Sumter City-County Planning Commission

March 25, 2015

MSP-15-16/HCPD-15-06, 1018 Manning Rd. & 1025 Pocalla Rd. – Markette #30 (City)

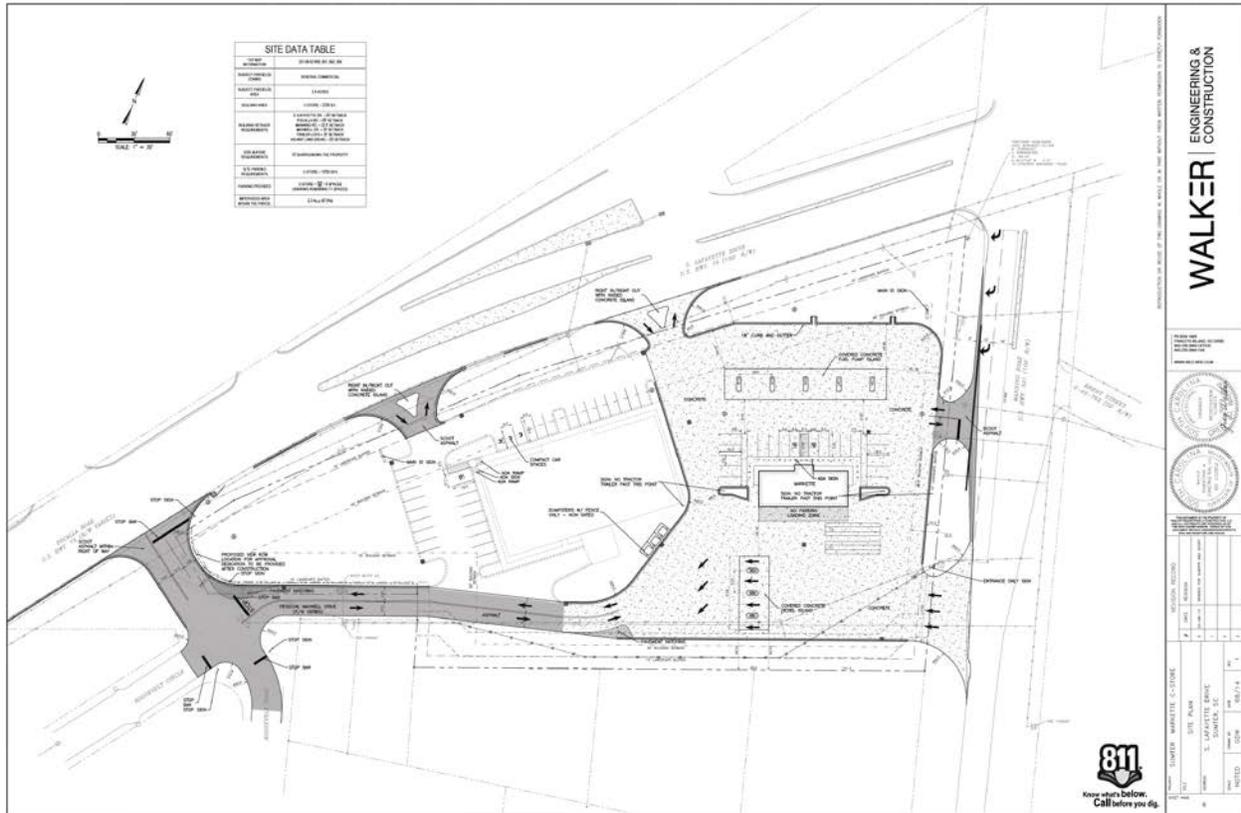
In addition areas of seasonal color will be planted along the Pocalla Rd. frontage. The landscape plan has been attached to this report for reference.

The stormwater management areas will be a series of dry ponds located along the Pocalla Rd. frontage, with one stormwater depression on Manning Rd. Due to the design of the ponds they will be sodded and treated as part of the development’s lawn.

This landscape plan meets the intent of the Ordinance.

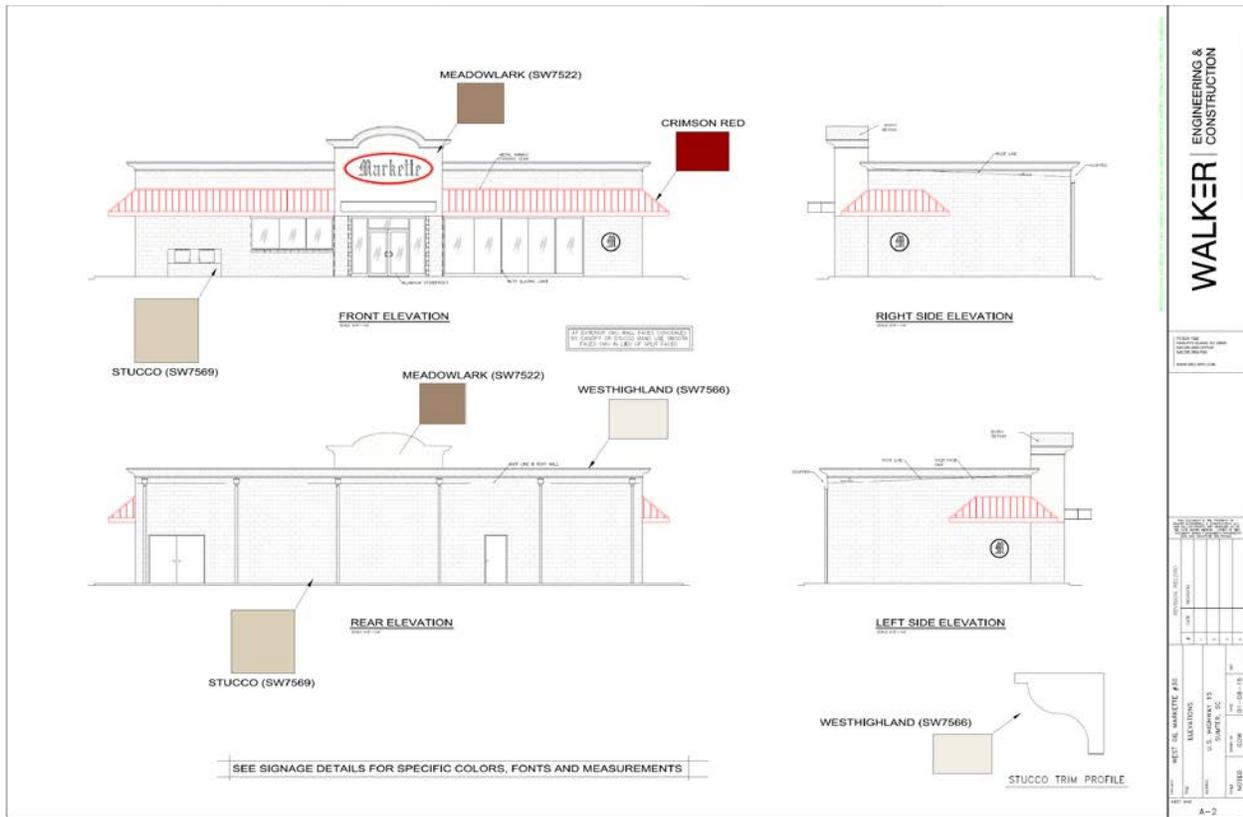
- a. If a new commercial building is proposed, not more than sixty percent (60%) of the facade facing a street may be glass or reflective materials;*

The proposed structure does not exceed the 60% threshold.

WEST OIL MARKET #33
 ELANDRUS
 U.S. HIGHWAY 15
 MARKET, SC
 MODEL
 DATE: 08-15-15
 A-2

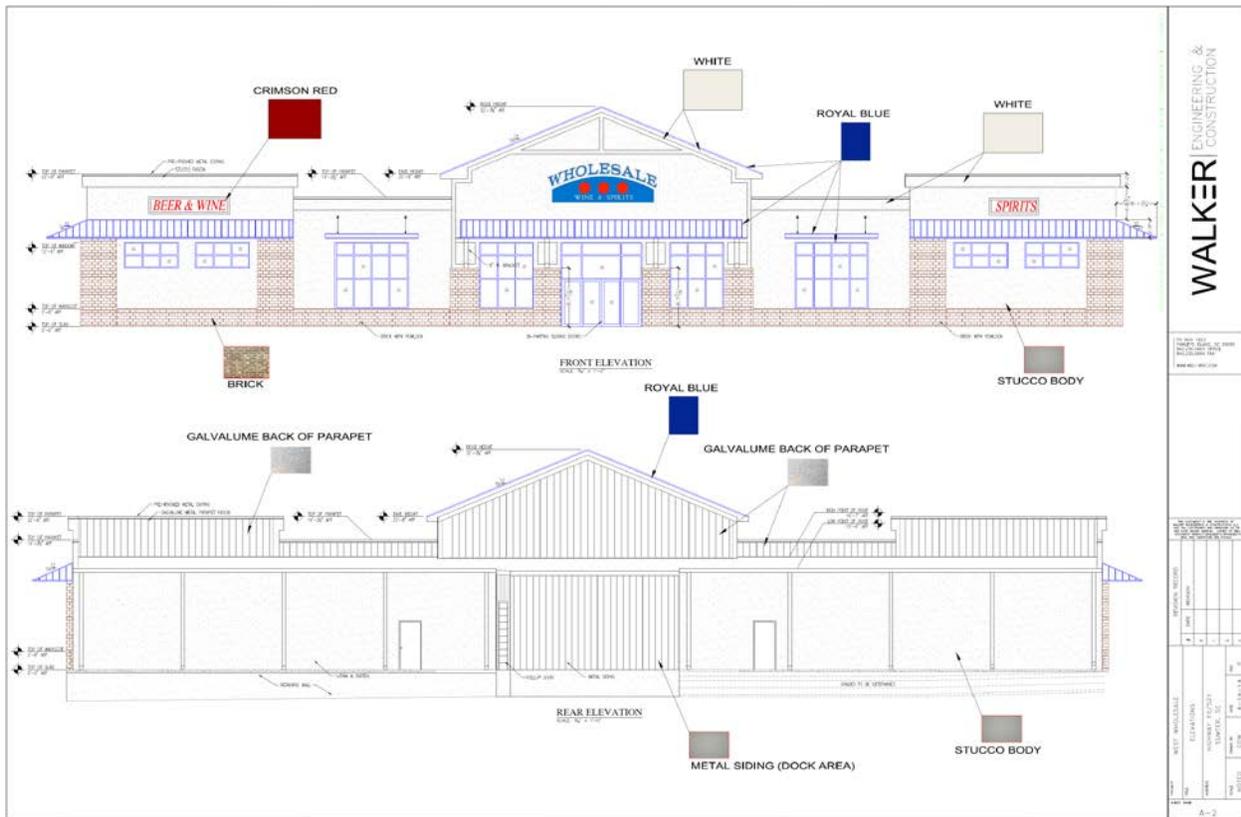
There are four structures proposed for this development – the convenience store, two gas canopies, and the wholesale liquor/beer and wine store. Building Elevations have been attached to this report. The exterior of the convenience store building will be a blend of split face CMU, smooth face CMU, EIFS and metal canopies. The proposed elevations for the convenience store and gasoline/diesel canopies are shown on the following pages. The primary building colors are earth tones with red accents on the metal canopies of the convenience store building. The diesel canopy will be grey, and the gasoline canopy is proposed to be red and white. Photographs of other Markette sites have been included to show the proposed canopy coloration and sizes.

The proposed roof pitch is complementary to and compatible with the existing smaller commercial structures in this area,
